Appl. No. 10/731,496
Amdt. dated April 4, 2007
Reply to Office action of March 13, 2007

AMENDMENT TO THE DRAWINGS

REMARKS / ARGUMENTS

Fig. 4

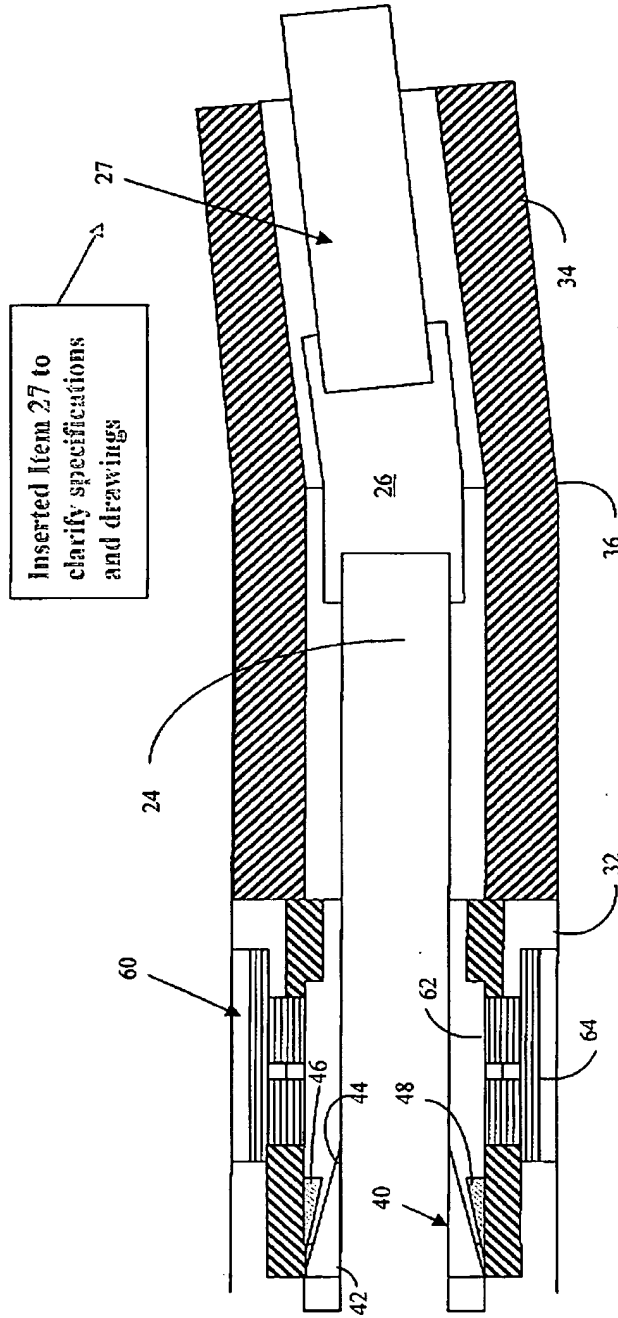
- Fig 4.
 - Numerical call out for Item 27 was inserted to provide clarity
